MEMORANDUM

Re: **Revised Landscaping Plan for John L. LeCave Memorial Trailhead (Ward One)**

SHEET TITLE
Landscape Plan

SHEET NUMBER
L1

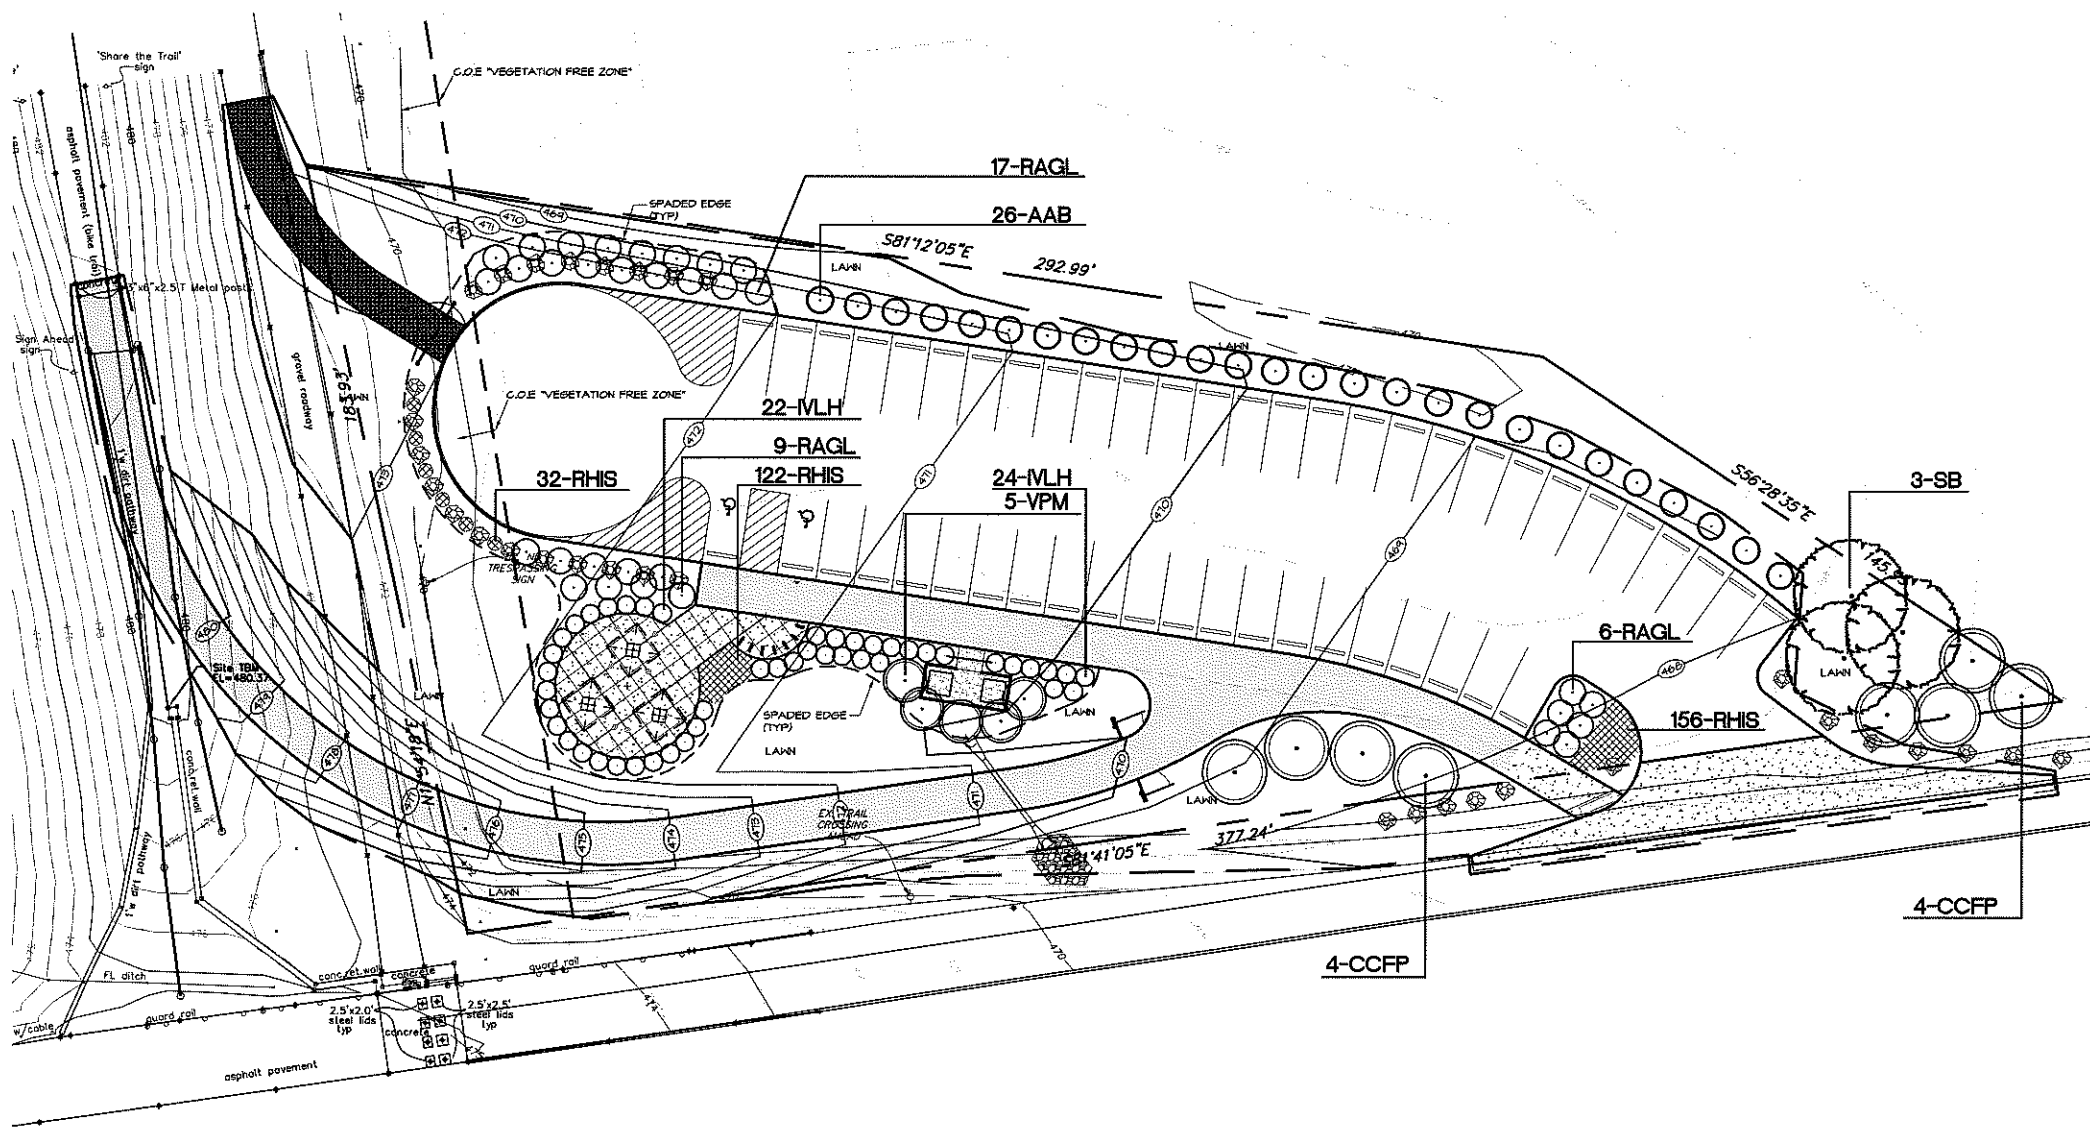
The plan has now been revised and the major improvements to it include the following items: (1.) the invasive Burning Bushes have been replaced with Chokeberries, while Weeping Willow Trees and Black-Eyed Susan plantings are included to reflect the LeCave Family's wishes in this regard. The revised Landscape Plan is attached for the Committee Members' review and comment. Two (2) items do remain before the plan and Resolution can be returned to the City Council for action, which includes the approval of the revised planting pattern by the U.S. Army Corps of Engineers and the Chesterfield-Monarch Levee District, given the levee structure and associated easements and also the selected bidder needs to review and update the pricing that are associated with these changes. However, before proceeding forward with these last two (2) steps, the Department of Planning and Parks wanted to provide the plan to the Committee Members and seek input and comments upon it. If the plan is acceptable, as revised, the next steps will be completed as quickly as possible, hoping to still be able to install the plantings in this area in early Spring.
